# Access Compliance Report

## Public Rights-of-Way

### (Curb Ramps)

Intersection ID: 9451	Main Street: BREWTON_DR	Cross Street: EUREKA_ST	Location:	N
ADA ID: F29A4EB5FFF4	Ramp Type: Perp	Initial Pass/Fail: Fail	Overall Compliance: No	Severity Score: 12.5

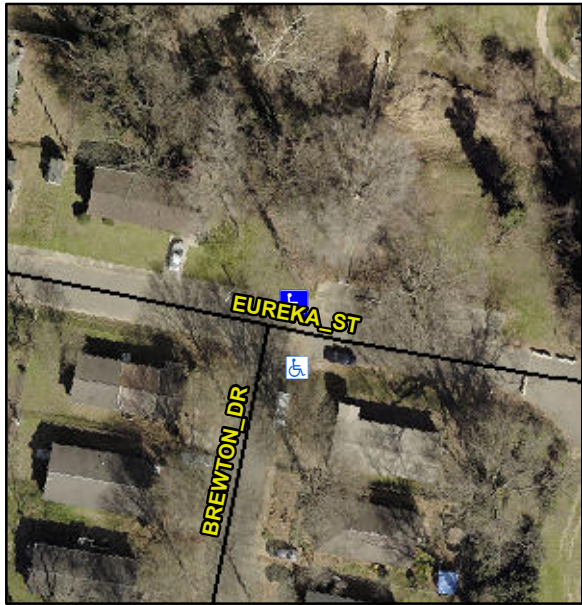
Codes/Mitigation Info/Possible Solution			Field Measurements/Component Compliance					
	Possible Solutions:		<b>Remove &amp; Replace Entire Ramp.</b>					
	Surveyor Notes:		<b>N/A</b>					
	PROW/ADA:		<b>Not Found, R304.2.2</b>					
	Total Cost:		\$ 1850.00					
	Street 1 Name		<b>EUREKA ST</b>					
	Stop Condition-Street 2		<b>None</b>					
	Street 2 Name		<b>N/A</b>					
	Stop Condition-Street 1		<b>N/A</b>					
			<b>Compliance</b>	<b>Description</b>	<b>Data</b>	<b>Compliance</b>	<b>Description</b>	<b>Data</b>
			<b>N/A</b>	Ramp Length (in)	<b>49.5</b>	<b>No</b>	Ramp Slope (%)	<b>10.5</b>
			<b>Yes</b>	Ramp Width (in)	<b>50.0</b>	<b>Yes</b>	Ramp XSlope (%)	<b>0.5</b>
			<b>N/A</b>	Flare Type LT	<b>N/A</b>	<b>N/A</b>	Flare Type RT	<b>N/A</b>
			<b>N/A</b>	Flare Slope LT (%)	<b>N/A</b>	<b>N/A</b>	Flare Slope RT (%)	<b>N/A</b>
			<b>N/A</b>	Flare Traversable LT?	<b>N/A</b>	<b>N/A</b>	Flare Traversable RT?	<b>N/A</b>
